Ashton Village Center

SECTOR PLAN

Ashton Village Center Sector Plan

Worksession #1

Ashton Village HOA Open Space

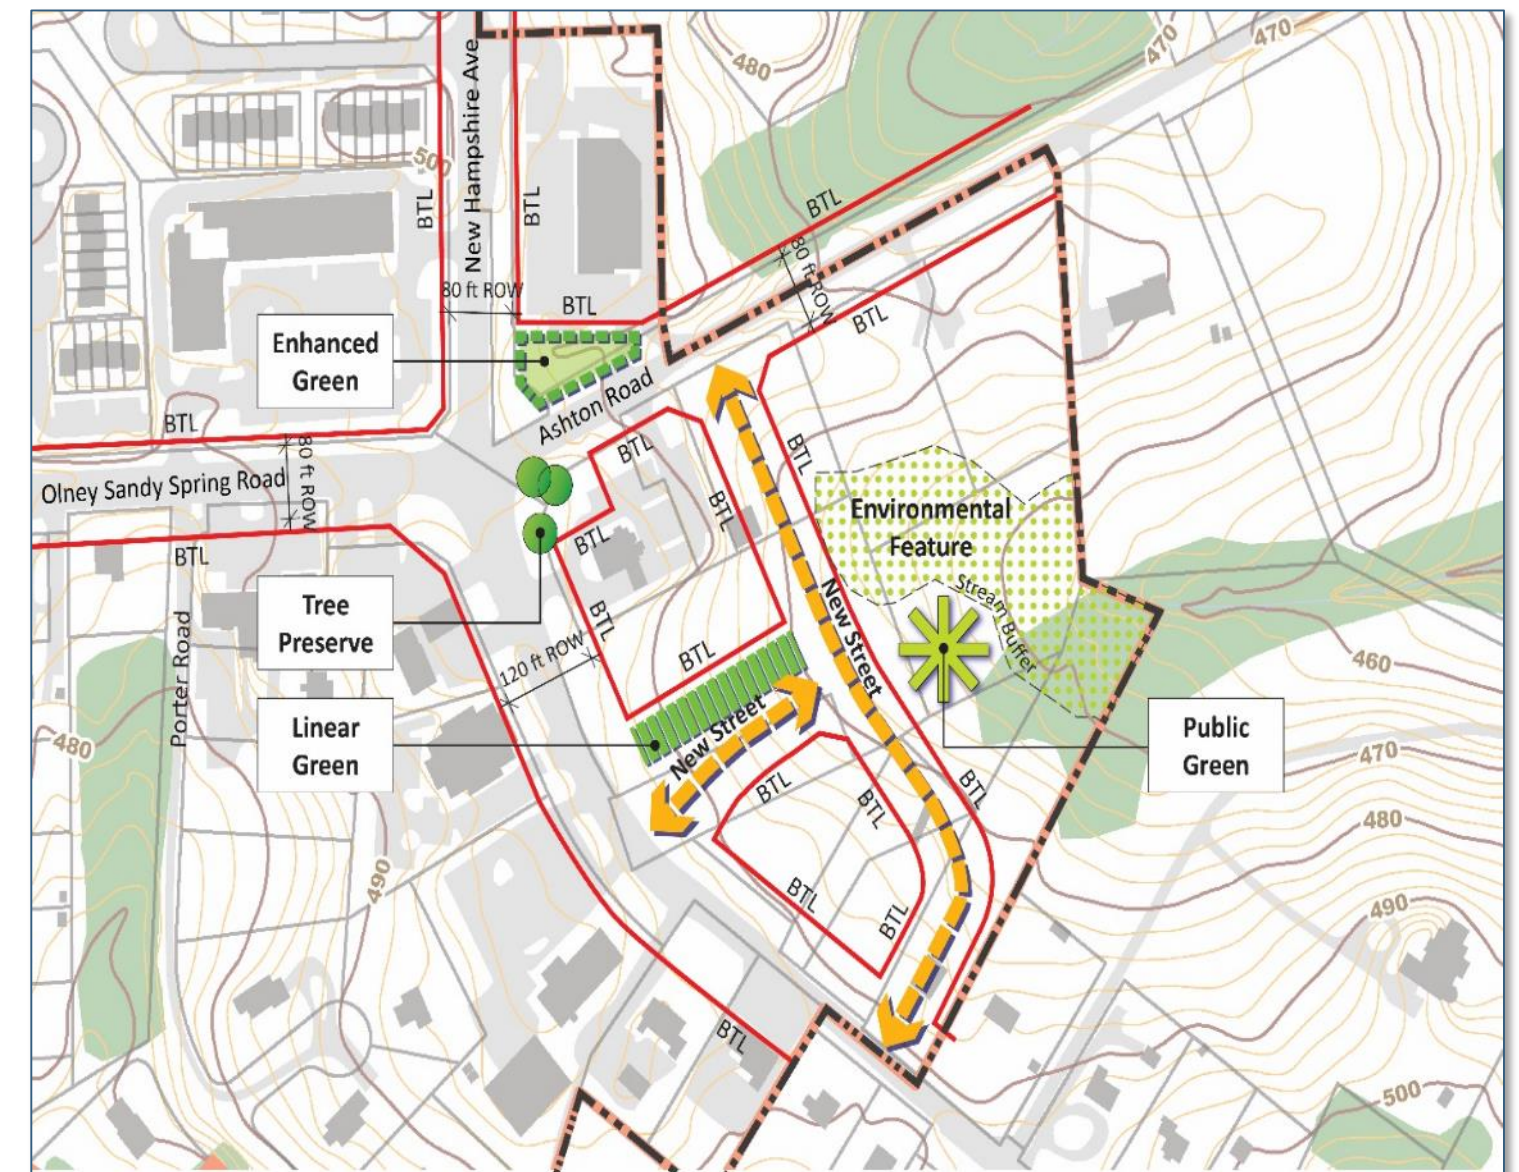
- Concerns that the Plan's language was too aggressive regarding the use of the HOA open space for a public gathering space, with particular concern about the additional vehicular and foot traffic such a space would attract

- Incorporate some of the HOA's suggested modifications to clarify the intent of the Plan

A view towards the environmental buffer in the southeast quadrant.

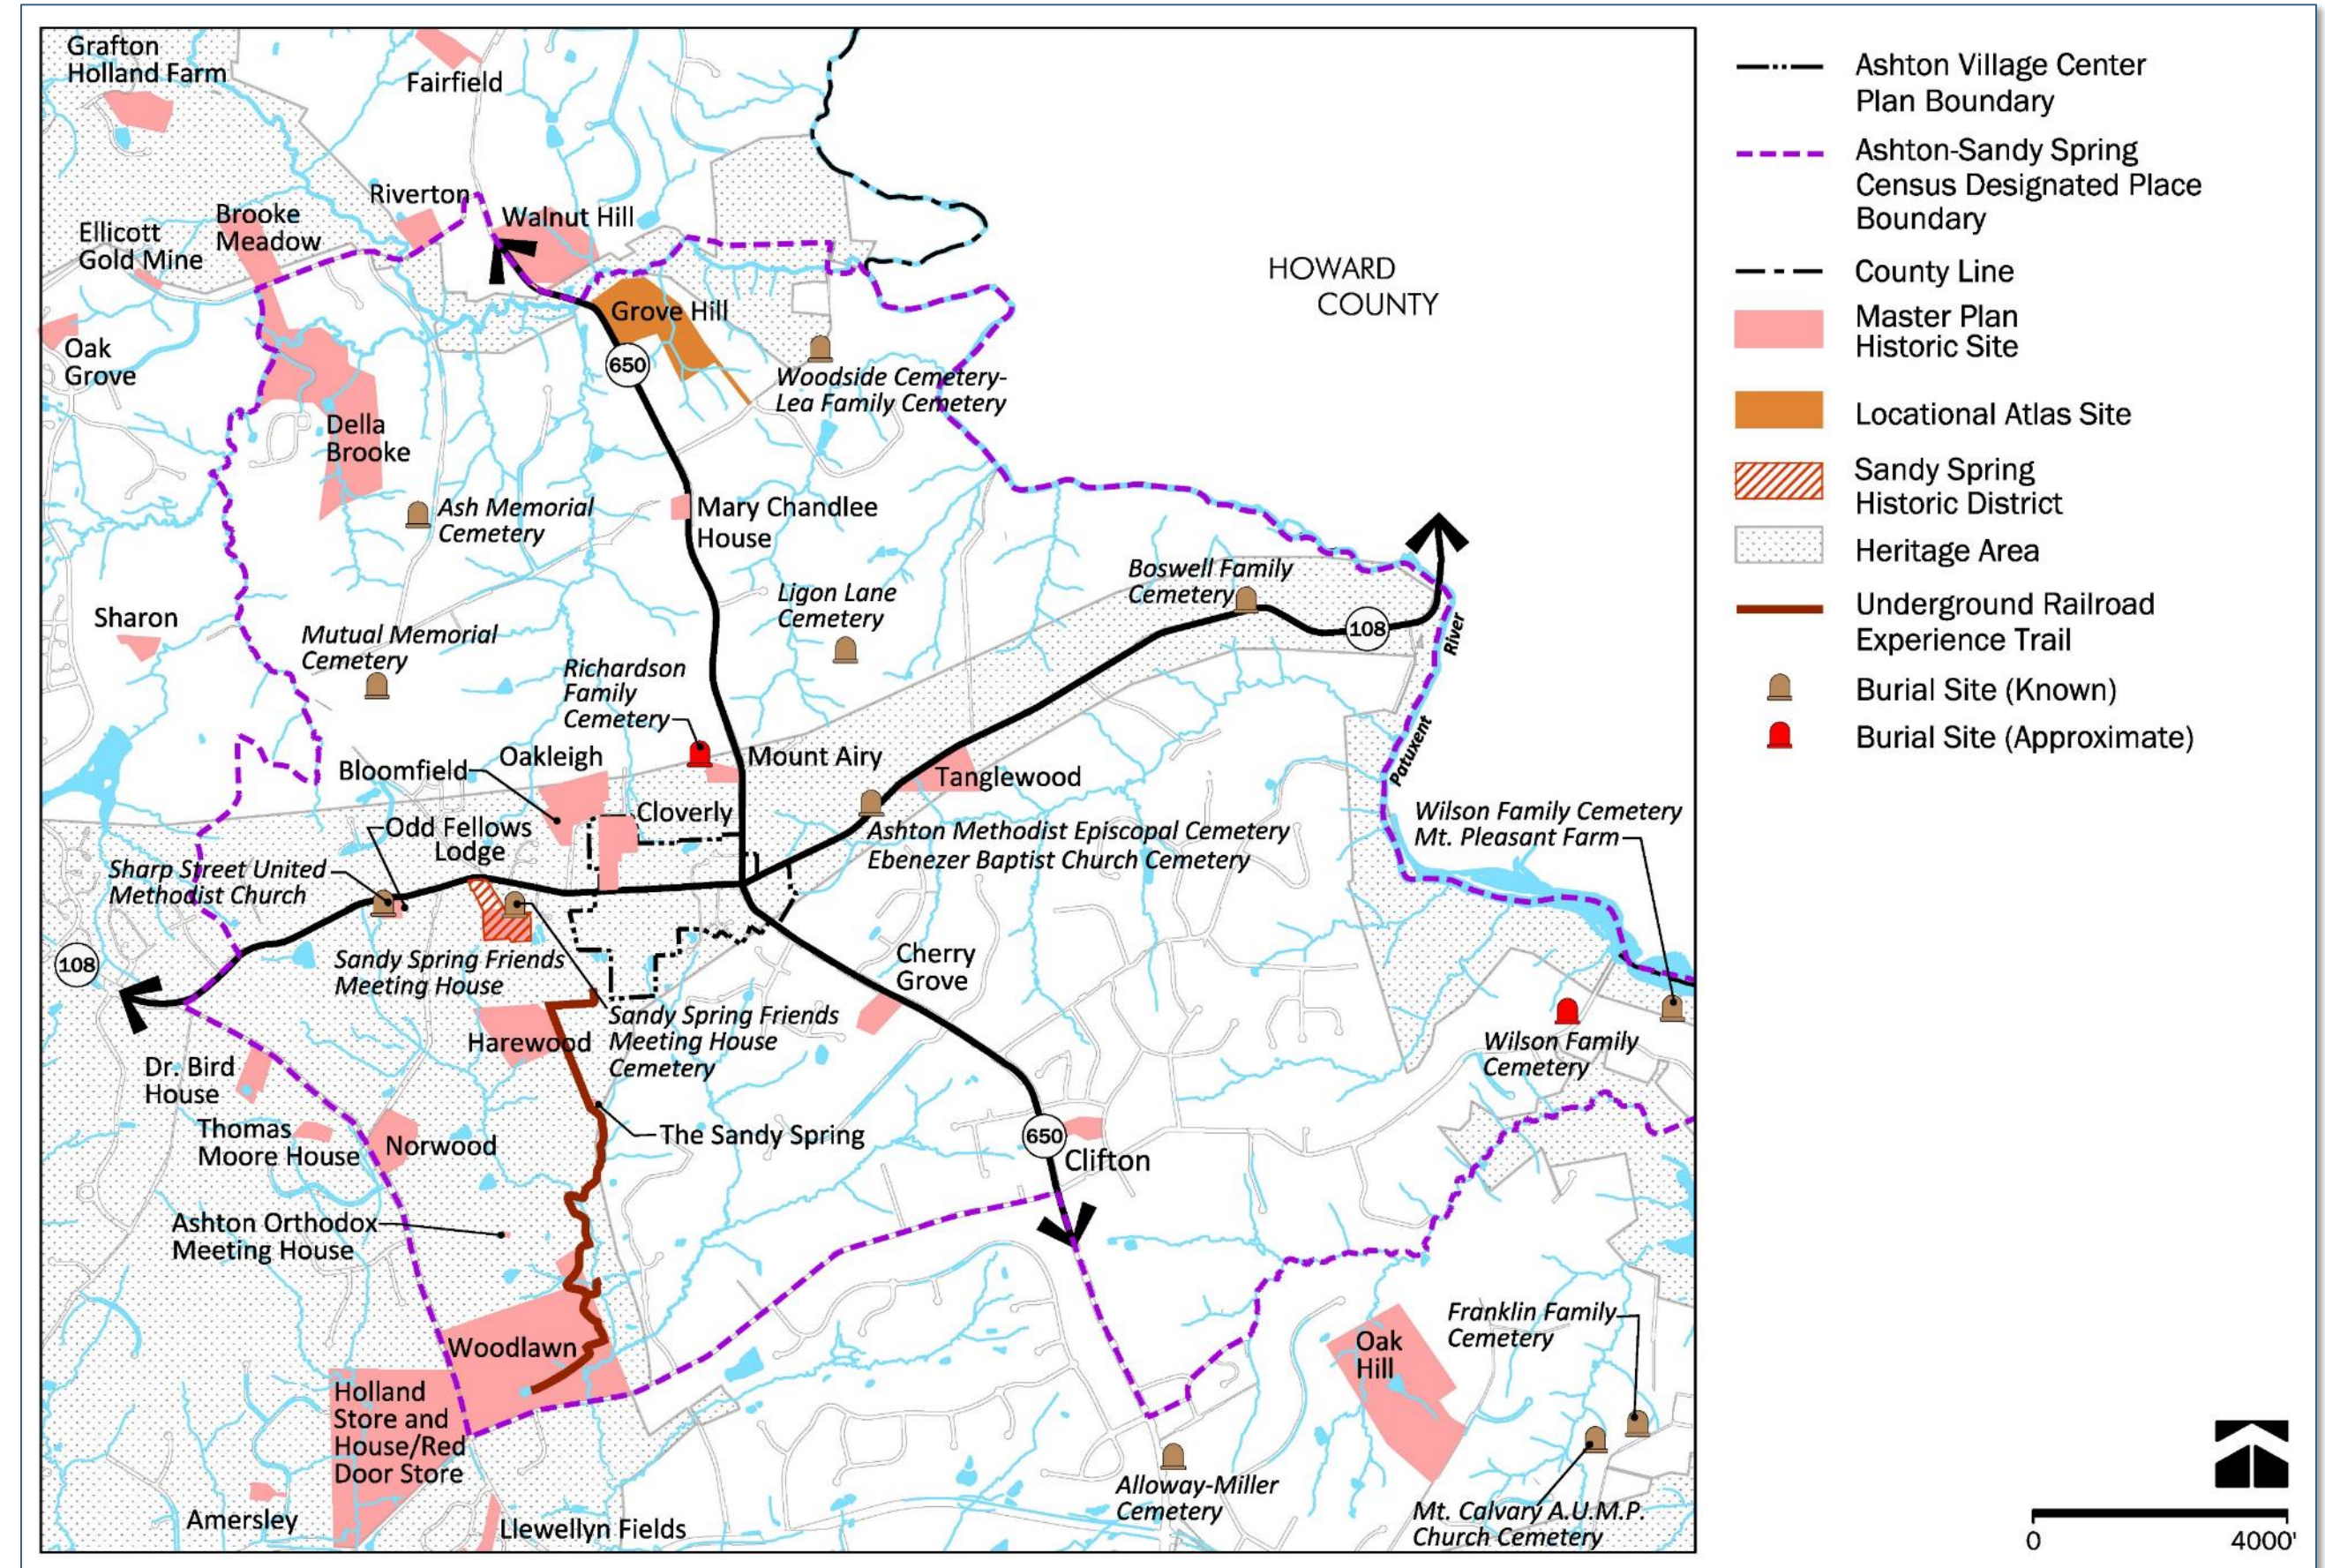
- Concerns that dense residential development in a rural area contradicts the county's policy to reduce greenhouse gas emissions
- The owner of the properties in the southeast quadrant requested revisions regarding the recommendation to maintain or plant shade trees

- Do not change Plan text. The Sector Plan doesn't designate strategic locations for the recommended trees; this will be addressed at development review

Southeast Quadrant

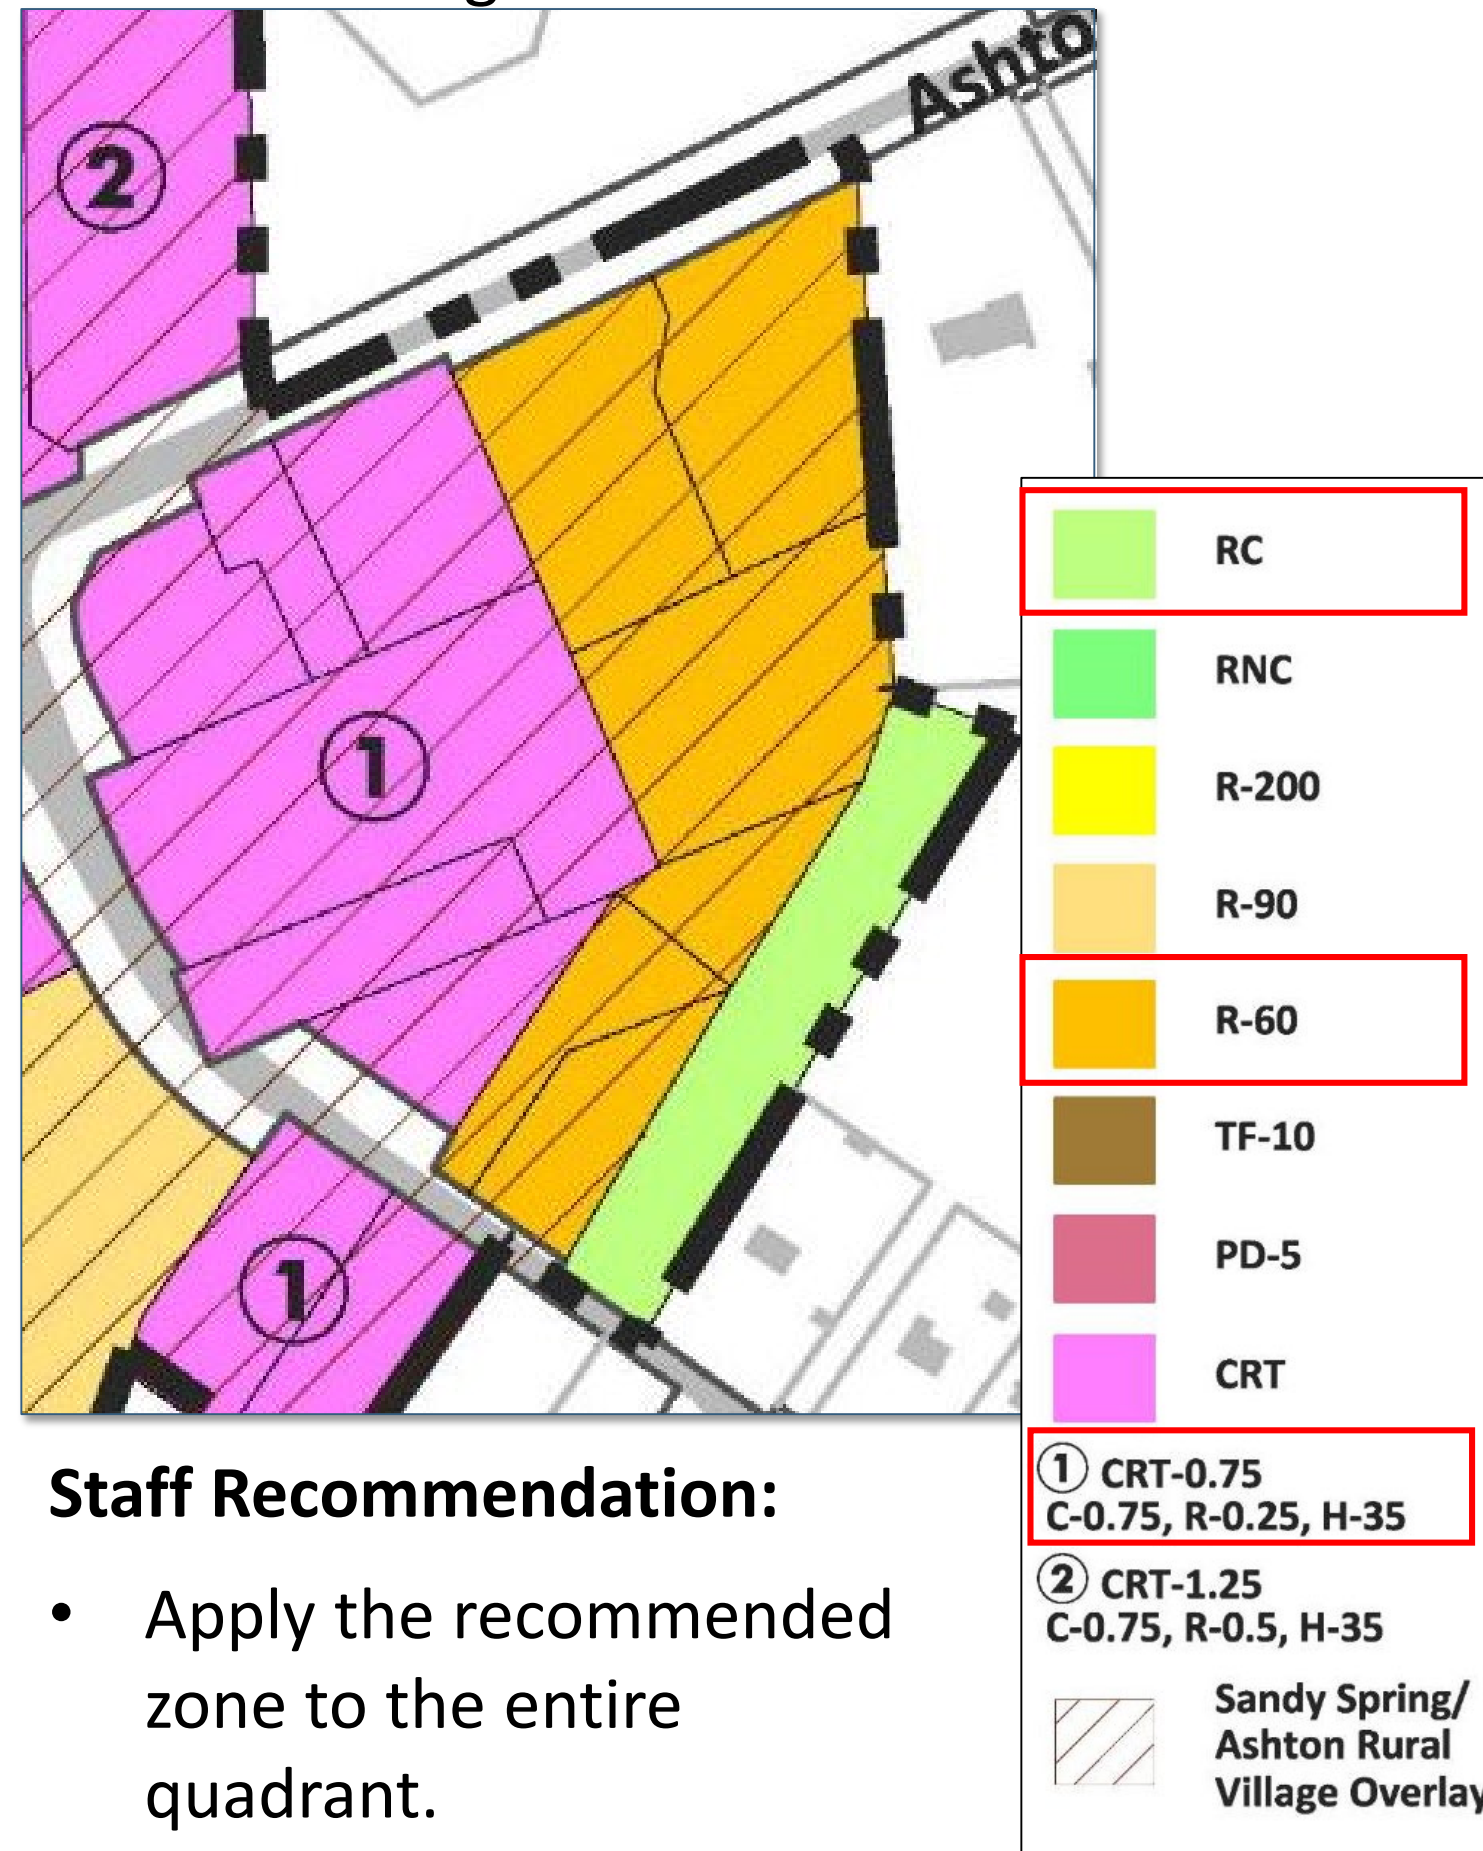
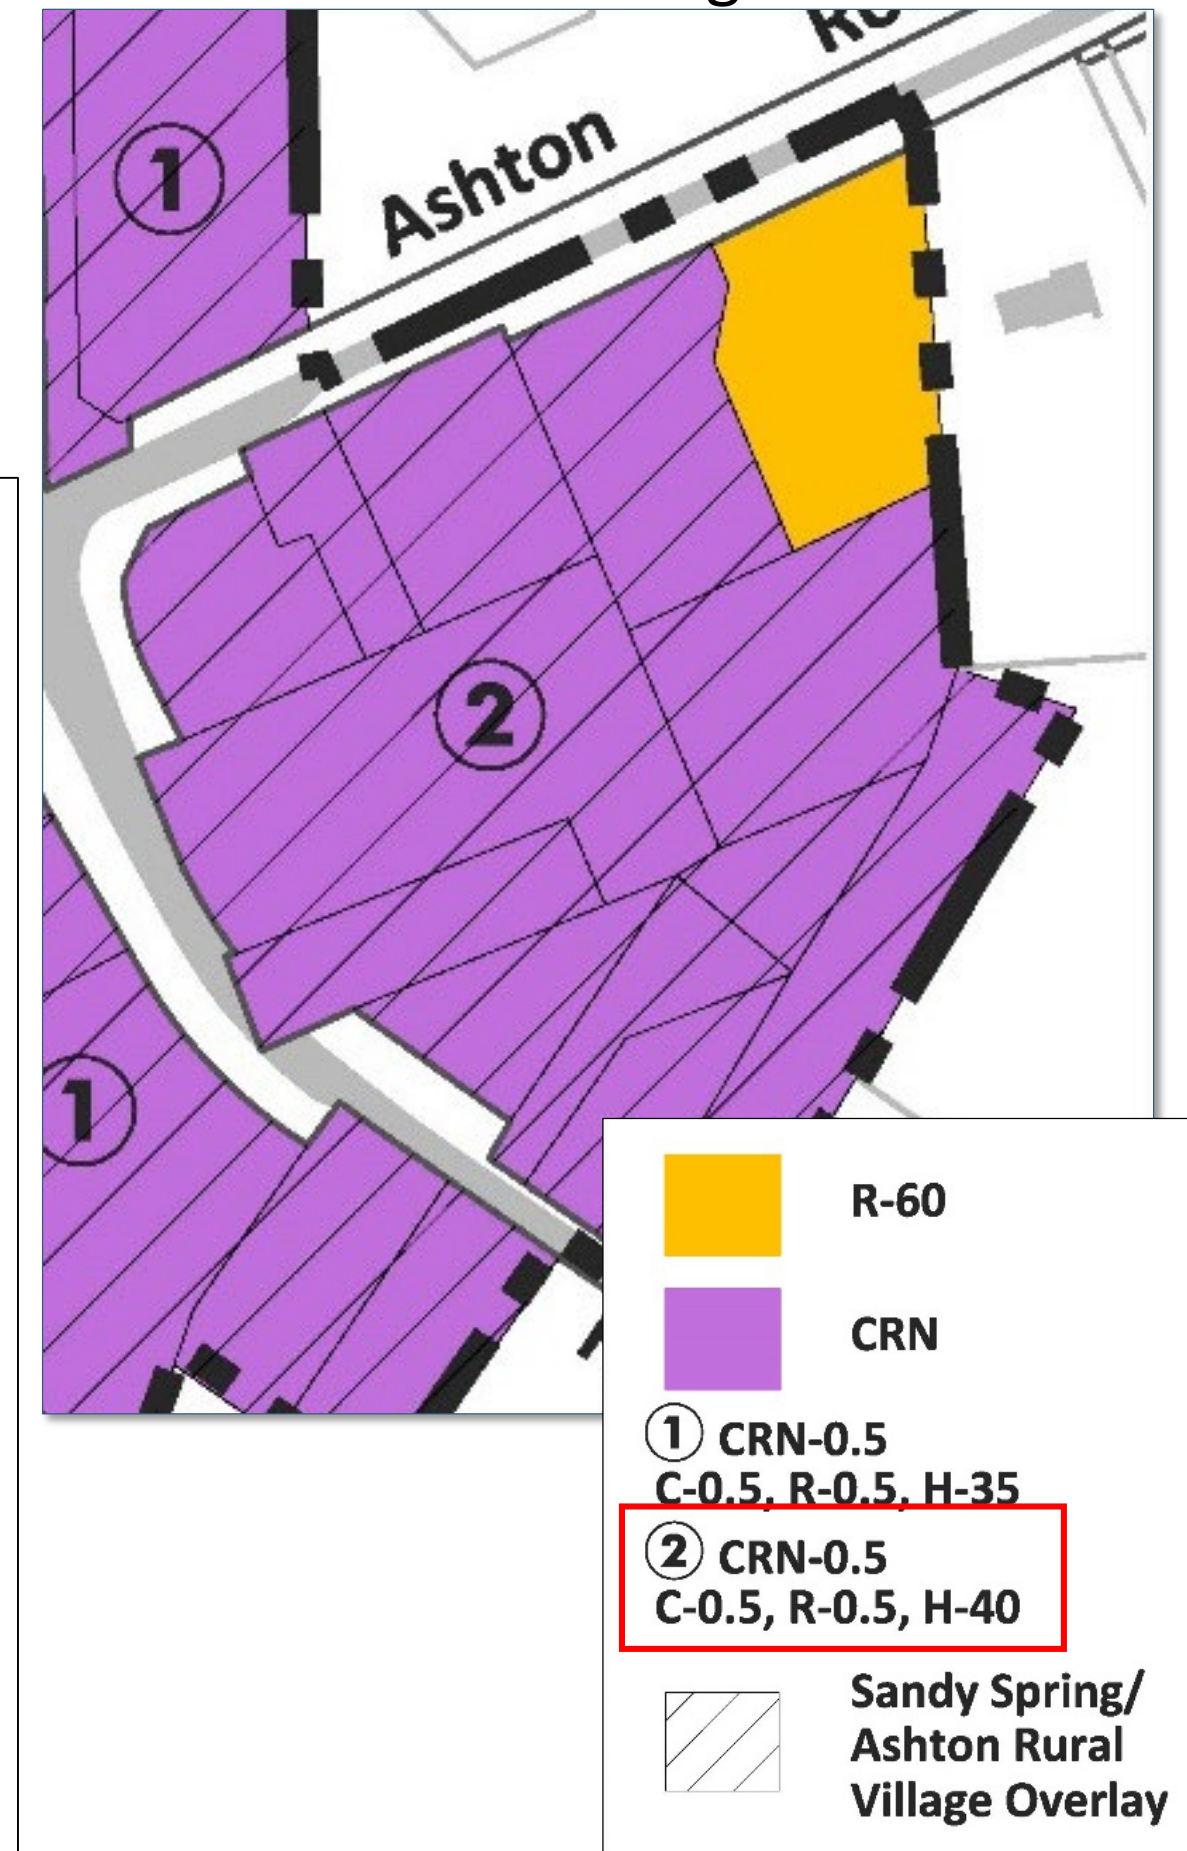
- Retain the current zoning: CRT-0.75 C-0.75 R-0.25 H-35, R-60 and RC
- Apply the Plan's recommended zone: CRN-0.5 C-0.5 R-0.5 H-40
- Apply a reduced version of the recommended zone: CRN-0.5 C-0.5 R-0.25 H-35
- Split zone the quadrant
- Apply an increased version of the recommended zone: CRN-0.75 C-0.5 R-0.5 H-45

- Apply the recommended zone to the entire quadrant.
